Access Compliance Report

Public Rights-of-Way

(Curb Ramps)

Intersection ID: 16168	Main Street: CORONADO_DR	Cross Street: FARMINGDALE_DR	Location: W
ADA ID: 45C801D799CC	Ramp Type: PerpDiag	Initial Pass/Fail: Pass	Overall Compliance: No
			Severity Score: 17.75

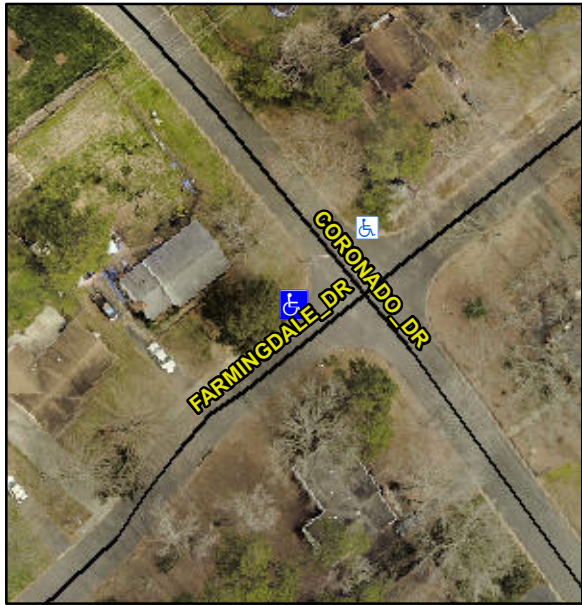
Codes/Mitigation Info/Possible Solution			Field Measurements/Component Compliance					
	Possible Solutions:		Compliance	Description	Data	Compliance	Description	Data
	Remove & Replace Curb Ramp With Two New Directional Ramps or Equivalent. Remove & Replace Gutter.		N/A	Ramp Length (in)	54.0	Yes	Ramp Slope (%)	7.4
			Yes	Ramp Width (in)	48.0	No	Ramp XSlope (%)	4.3
			N/A	Flare Type LT	Sloped	N/A	Flare Type RT	N/A
			N/A	Flare Slope LT (%)	9.6	N/A	Flare Slope RT (%)	4.5
			N/A	Flare Traversable LT?	Yes	N/A	Flare Traversable RT?	No
			No	Landing Length (in)	N/A	Yes	DWS Provided?	Yes
			No	Landing Width (in)	N/A	Yes	DWS Contrast?	Yes
			No	Landing Slope (%)	N/A	Yes	DWS Length (in)	24.0
			No	Landing X Slope (%)	N/A	Yes	DWS Full Width?	Yes
Surveyor Notes:		N/A	N/A	Landing Curb? (Y/N)	No	Yes	DWS Offset (in)	0.0
			N/A	Shared Landing?	N/A			
PROW/ADA:		Yes	Gutter Ponding?	No	Yes	Gutter Slope (%)	0.6	
		No	Gutter Lip Ht (in)	0.5	No	Gutter X Slope (%)	3.3

N/A	Painted X Walk1?	No	N/A	Painted X Walk2?	No	
			X Walk 1 Direction	To SE		X Walk 2 Direction	To NE	
		N/A	X Walk 1 Width (in)	N/A	N/A	X Walk 2 Width (in)	N/A	
			X Walk 1 Slope (%)	4.3		X Walk 2 Slope (%)	0.8	
			X Walk 1 X Slope (%)	0.5		X Walk 2 X Slope (%)	7.3	
		N/A	Ramp inside XWalk1?	N/A	N/A	Ramp inside XWalk2?	N/A	
			Road Slope (%)	2.4	N/A	Clear Space?	Yes	
			Road X Slope (%)	6.4	N/A	Clear Space to XWalk (in)	N/A	
		Yes	Any Obstructions?	No	Yes	Storm Grate/Utility Hazard?	No	
			Obstruction Type			Storm Grate/Utility Type		
					N/A		N/A	
					Yes	Surface Condition? (G/P)	Good	
Total Cost:		\$ 3950.00
